## CDM: Recommendation Form for Small Scale Methodologies (version 01)

<b>Date of SSC WG meeting:</b>	29 April–02 May 2009, SSC WG 20
<b>Title/Subject (give a small title or specify the subject of your submission, maximum 200 characters):</b>	Applicability of AMS-III.H to project activity involving flaring/combustion and utilization of recovered biogas
<b>Indicative methodology to which your submission relates (refer the items of Appendix B of the Simplified Modalities and Procedures), if applicable.</b>	AMS-III.H
<b>Name of the authors of the query:</b>	Niroj Mohanty Institution: Core CarbonX Solutions Pvt Ltd <a href="mailto:nmohanty@corecarbonx.com">nmohanty@corecarbonx.com</a>

The figure below describes the baseline (existing) scenario:

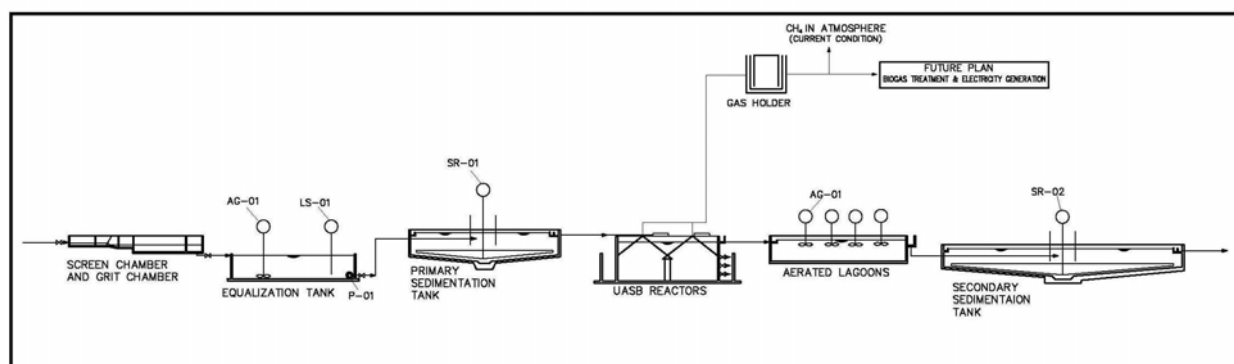
The existing system is only having methane recovery system and is not an inter related and integral activity of methane recovery and methane combustion. We kindly request guidance on the applicability of current version of AMS-III.H to the situation mentioned above, where the wastewater treatment and biogas recovery takes place in the baseline and the project activity will introduce flaring/combustion and utilization measures to the recovered biogas. Furthermore if expedient and in conjunction with the project activity illustrated above we are seeking guidance on potential subsequent steps to be undertaken on the AMS-III.H (e.g. deviation/extension/revision of the AMS-III.H.).

The SSC WG would like to clarify that AMS III.H aims at the introduction of biogas recovery and combustion and that it does not apply to the situations where biogas recovery is already taking place, as is the case of the submission. The situation where there is already an anaerobic digestion system in combination with biogas capture is not considered to be a credible baseline scenario under AMS-III.H.

If the project activity meets the CDM requirements, the project proponents might still use a Type I methodology for the biogas utilization component.
